**CITY OF WINTER PARK
PLANNING AND ZONING BOARD**

**Staff Report
March 6, 2018**

SPR 18-03 REQUEST OF WINTER PARK DESIGN FOR APPROVAL TO CONSTRUCT A NEW 5,758 SQUARE FOOT SINGLE-FAMILY HOME LOCATED AT 1234 LAKEVIEW DRIVE ON LAKE VIRGINIA, ZONED R-1AAA.

REQUEST OF VERAX INVESTMENTS, LLC FOR: CONDITIONAL USE APPROVAL TO CONSTRUCT A TWO STORY, 20,000 SQUARE FOOT MEDICAL AND GENERAL OFFICE BUILDING ON THE PROPERTY AT 1111 WEST FAIRBANKS AVENUE, ZONED C-3.

OPTION 2

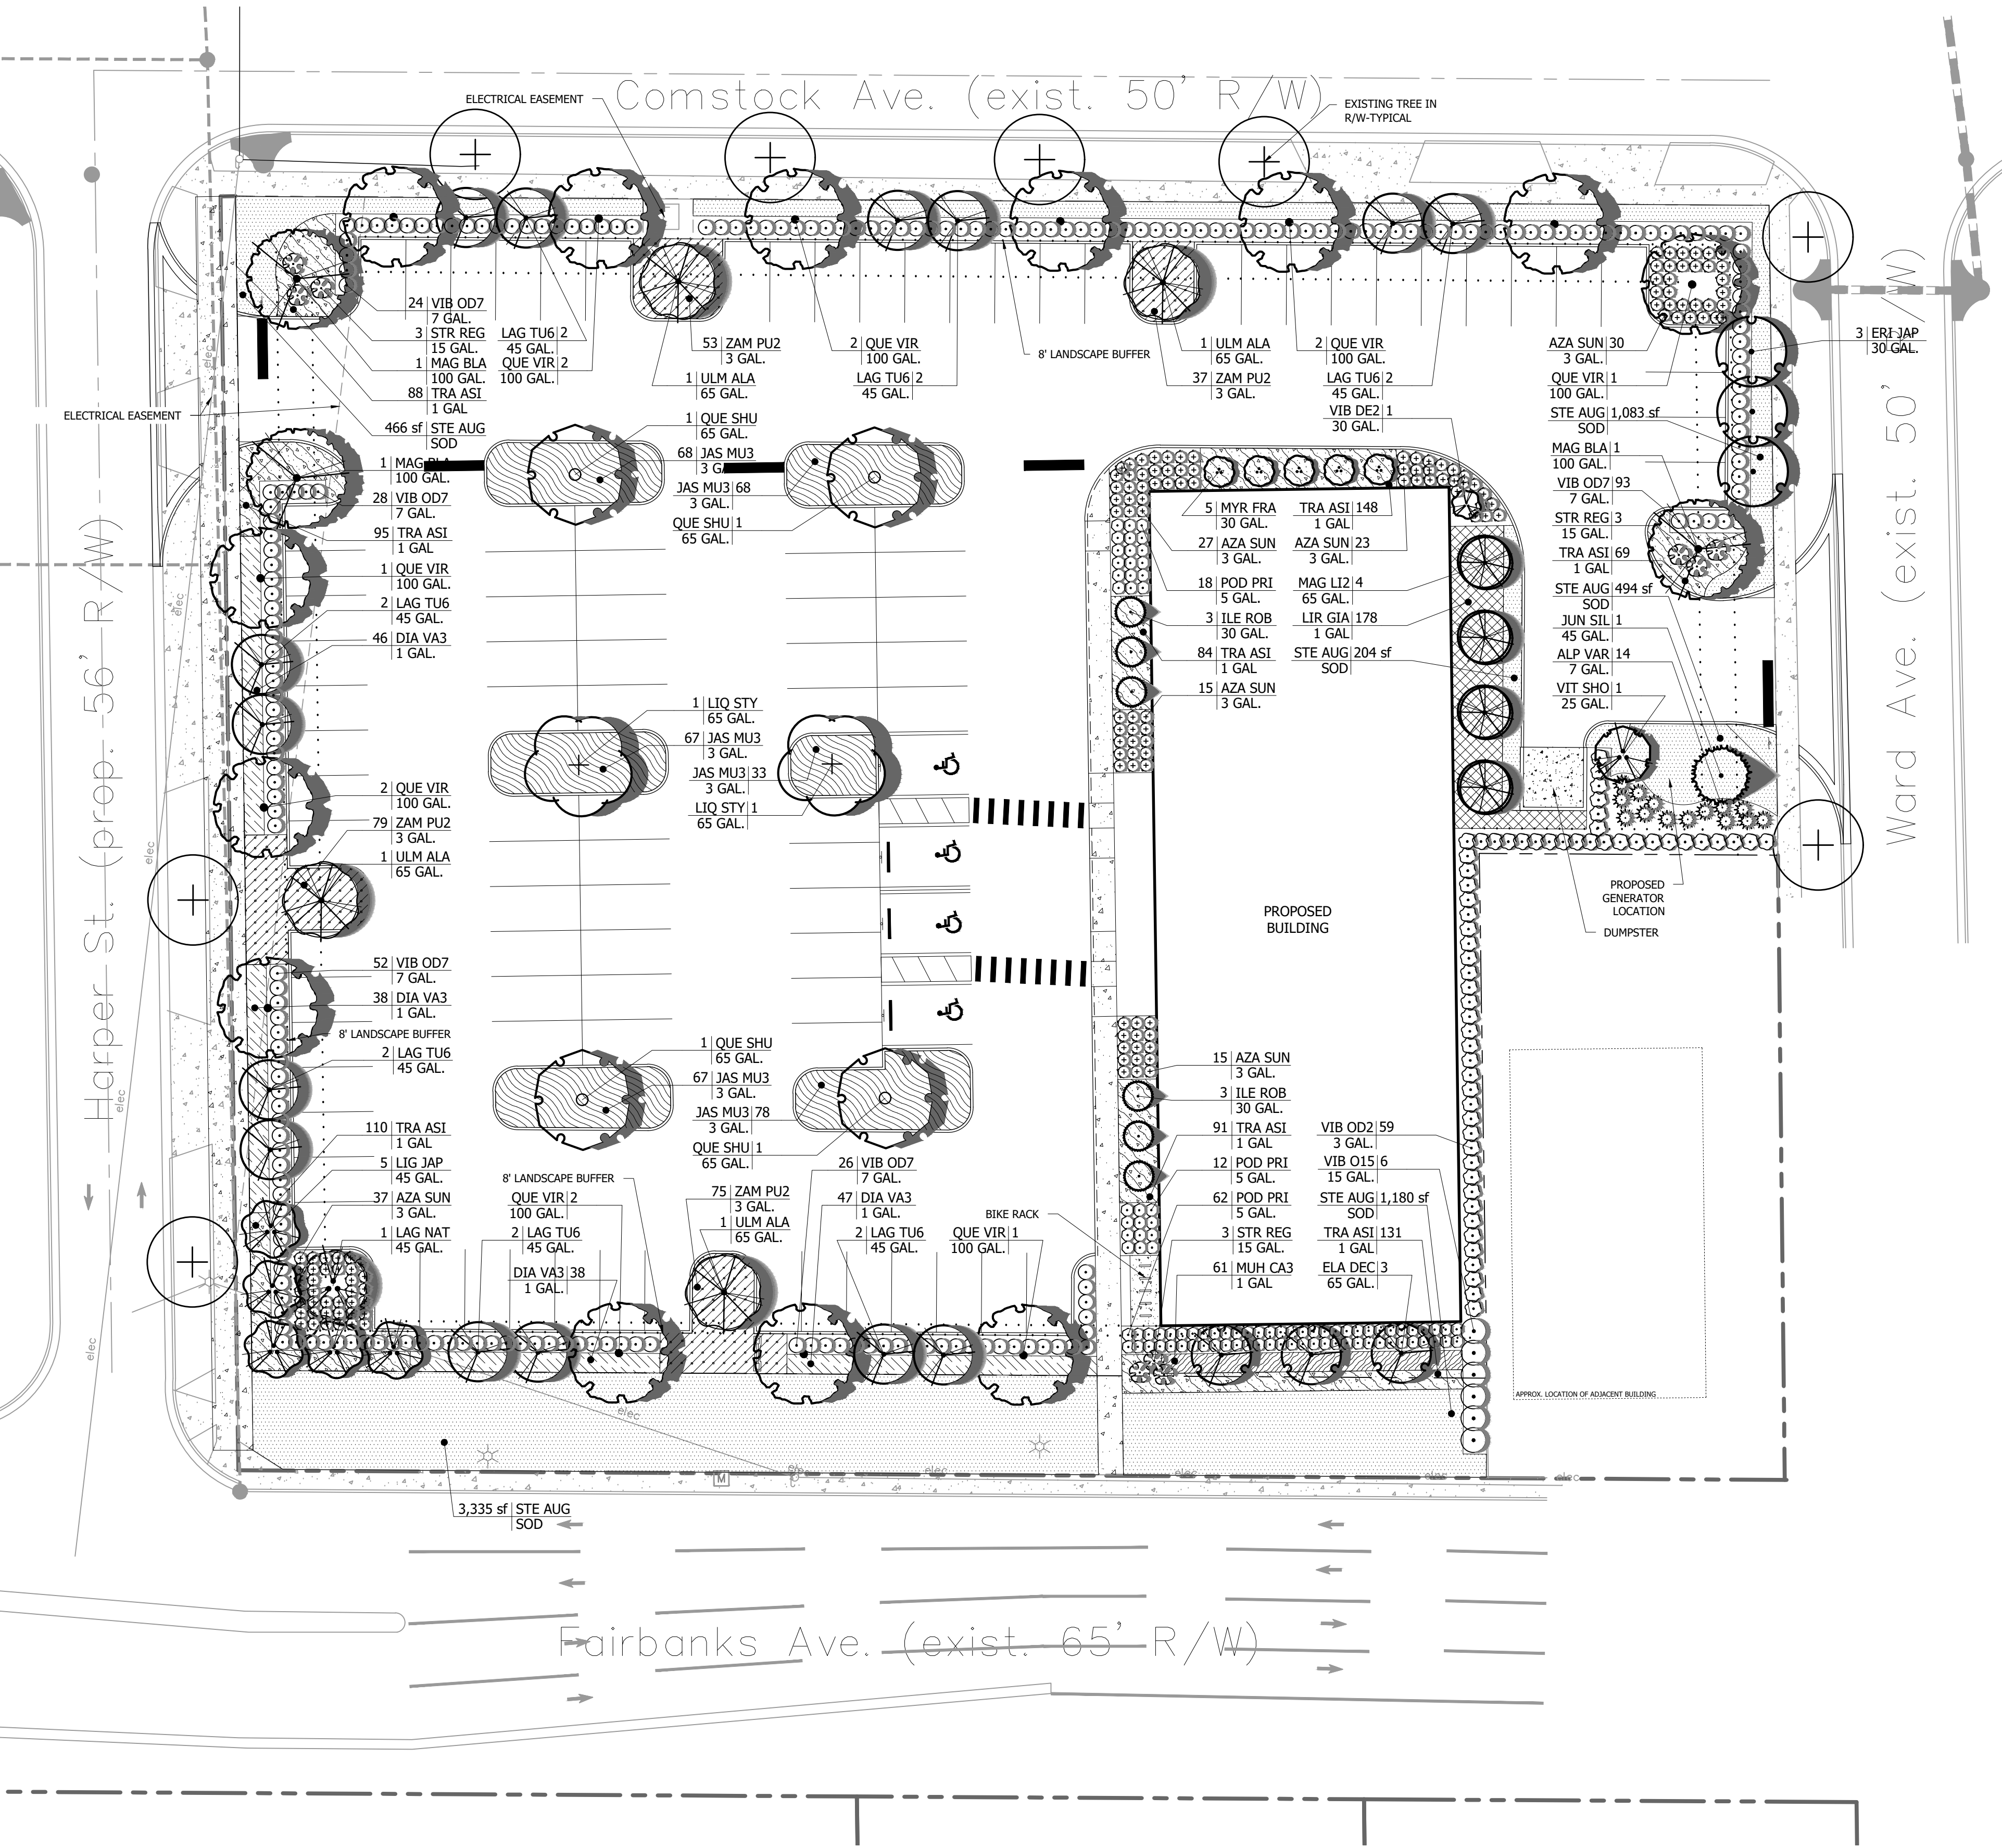
Option B locates the building in an east/west orientation parallel to Fairbanks Avenue. Again excluding the Harper Street right-of-way and Walgreens, it provides for an 80 foot view shed across the parking lot toward MLK Jr. Park. This option is approximately 20,800 square feet in size, has a FAR of 30% which is below the code maximum of 45%. This option also meets all of the Code requirements with respect to building heights, setbacks, and impervious coverage.

The advantage of Option B is that the building screens more of the view of the parking lot along the Fairbanks Avenue frontage. This placement also coincides with the urban form that staff has developed for design guidelines along other corridors. Another advantage of Option B is that it allow more space for landscaping along the Fairbanks Avenue frontage. A disadvantage of Option B is that it faces the less attractive narrow side end wall of the building toward the 20,000 cars traveling east each day.
